MIL-V-8608A
AMENDMENT 2
9 November 1966
Superseding
AMENDMENT 1
21 June 1966

VALVES, FUEL SHUTOFF, ELECTRIC MOTOR OPERATED

This amendment forms a part of Military Specification MIL-V-8608A, 19 April 1963, and is mandatory for use by all Departments and Agencies of the Department of Defense.

FIGURE 3. Wiring diagram

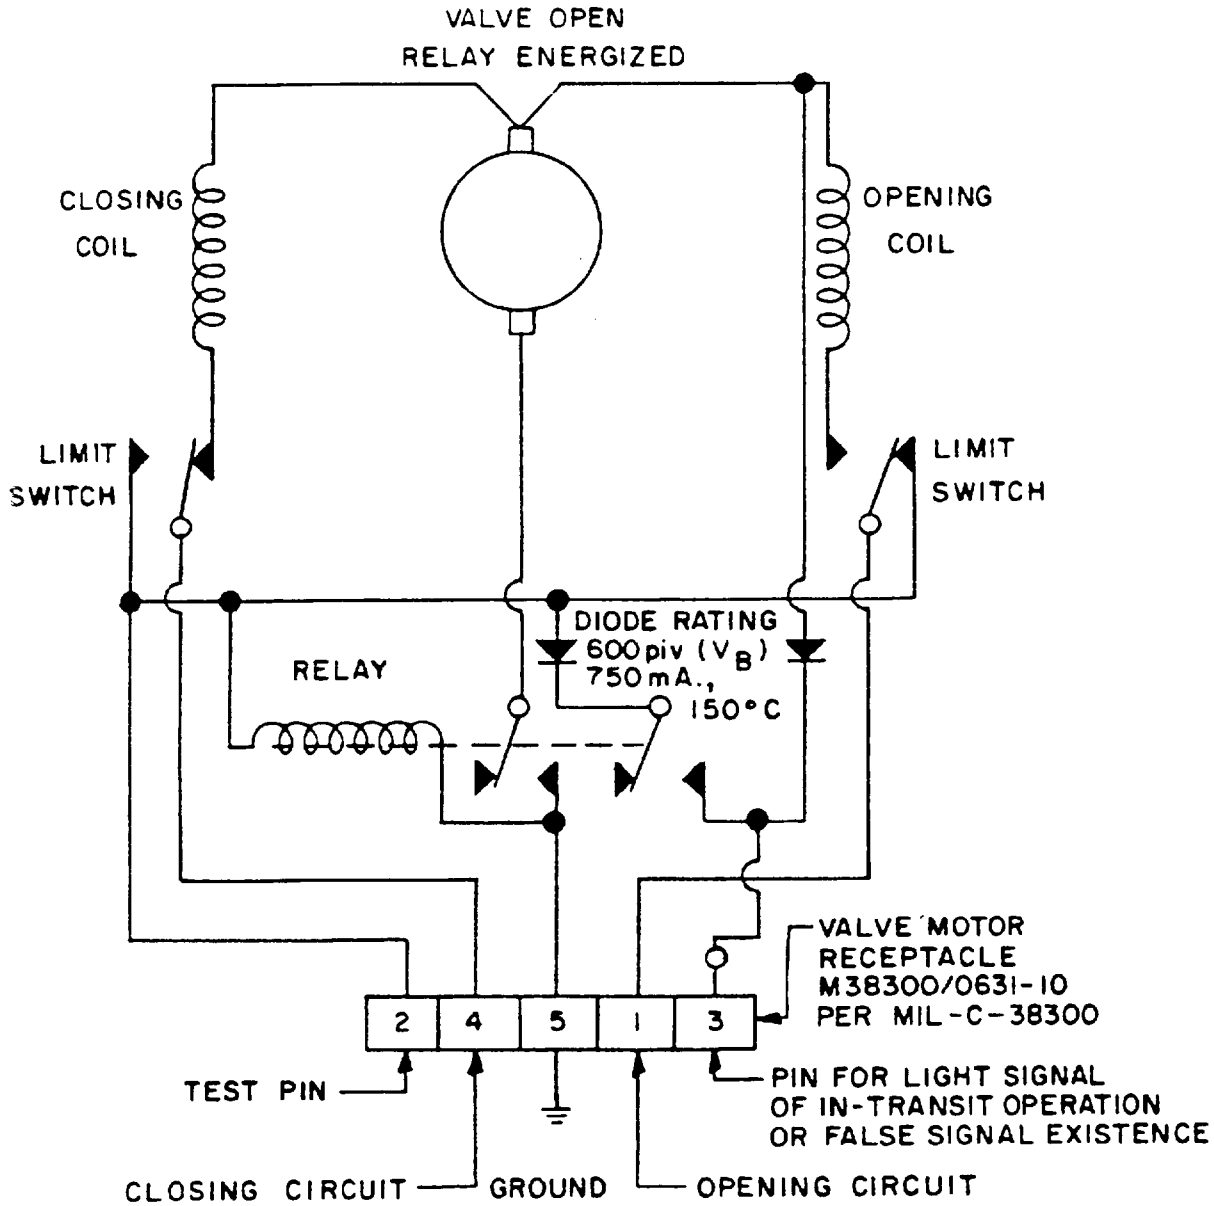
"3.3.5 Indicator circuits. Indicator circuits shall be provided in accordance with figure 3."

"3.5.5 Electrical connectors. Electrical connectors shall conform to MIL-C-38300 of the part number shown on figure 3."

"3.5.7 Electrical failure. The valve electrical circuit shall conform to figure 3 to provide protection against inadvertent actuation of the valve due to electrical short circuits. The valve shall not change positions due to electrical power failure."

(Add new figure 3 Wiring diagram, attached.)

“3.5.10 Semiconductors. Diodes used in the valve electrical circuit shall be one of the “preferred” types selected from MIL-STD-701 with a minimum rating as specified on figure 3.”
